**Re: Planning Review #3
Application #14-21
Site Plan w/ Variances
Block 1901, Lot 40
40 Russo Place
Michael Cline c/o First Student, Inc.
LI Light Industrial District**

This is the third review letter issued in association with the above-mentioned project. The applicant proposes to convert the existing site, which is currently used by a non-conforming environmental waste recovery company, into a school bus parking lot with associated administrative office space. Following the last hearing, the applicant has provided revised plans and additional materials; we are in receipt of and have reviewed the following:

Figure 1: Location of Robbins Avenue Branch tributary (in blue)

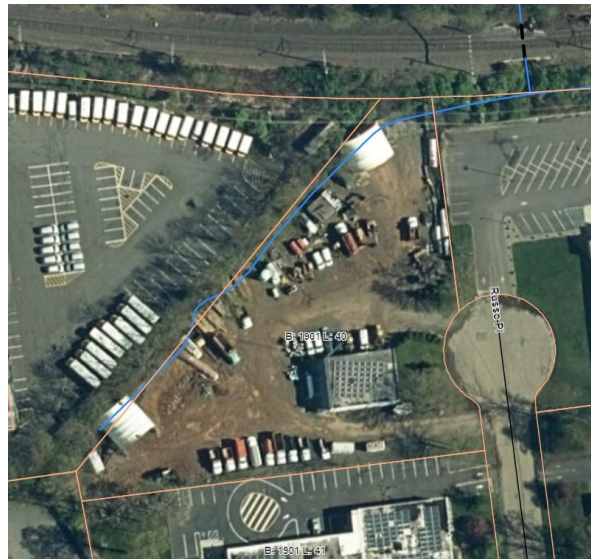
- Activities and improvements within a riparian zone: The Robbins Avenue Branch tributary appears to run along the western property line. The location can be observed on the National Hydrography Dataset for New Jersey provided on NJ Department of Environmental Protection’s NJ-GeoWeb mapping service (see Figure 1). Pursuant to §15.28.240.3, a 50-ft wide riparian zone is required on both sides of a surface water body, and up to 150 feet may be required if the brook is considered a trout production water or an upstream tributary.

The applicant in the Response Letter noted that a pipe was previously installed within the stream, and that it is difficult to confirm the location of the bank and the associated riparian zone. The Board should note that this pipe was the subject of a NJDEP violation citation issued to the previous owner.

The current applicant indicates that they have revised the site layout to accommodate a restored tributary and its riparian zone. They have submitted for permitting to the NJDEP and is currently undergoing review.
